**ALERT SERVICE BULLETIN
REVISION NOTICE**

**SUBJECT: REVISION A TO ALERT SERVICE BULLETIN 427-09-29:
TAIL ROTOR DRIVESHAFT HANGER BEARING BRACKET P/N 427-
044-223-101, REWORK OF.**

NO. 427-09-29

REV A

Figure I

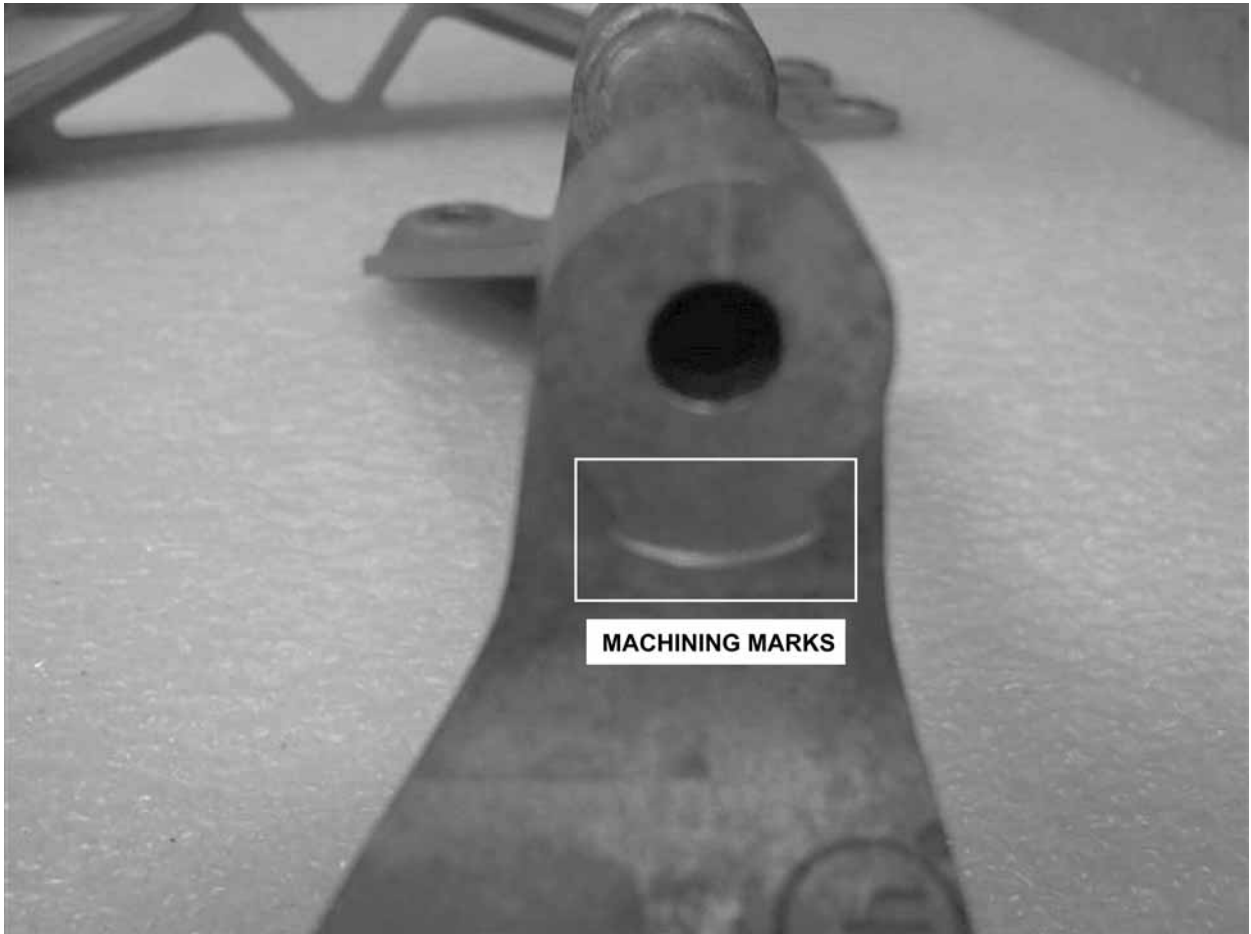
Bell Helicopter received a report of a broken tail rotor driveshaft hanger bearing bracket P/N 427-044-223-101. Investigation revealed that the part fractured due to fatigue. The crack originated in the radius near an area where a tool had cut into the bracket for a flat faying surface. Refer to Figure 1 for details.

Machining marks on bracket P/N 427-044-223-101

Figure 2

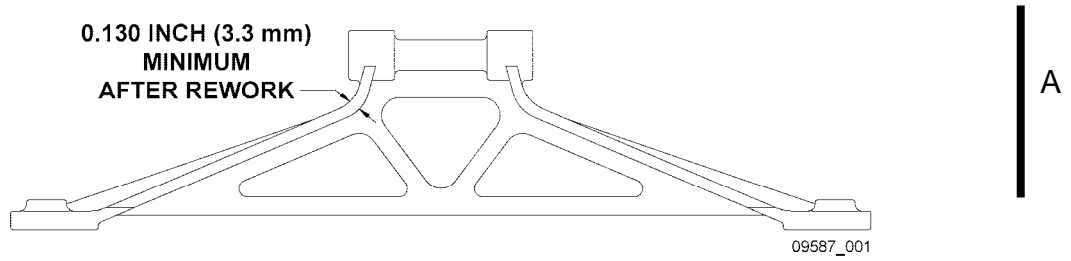
Revision A to this bulletin is issued to change the bracket web minimum thickness from 0.140 to 0.130 inch after rework.

7. Rework both side of bracket P/N 427-044-223-101 as follows:
 - a) Using 180 grit sand paper, polish out the noted machining step smooth with the adjacent surfaces. Remove minimum material needed to remove the machining marks in the radius area. Maintain existing 0.50 radius and minimum web thickness of 0.130 inch. Refer to Figure 2.
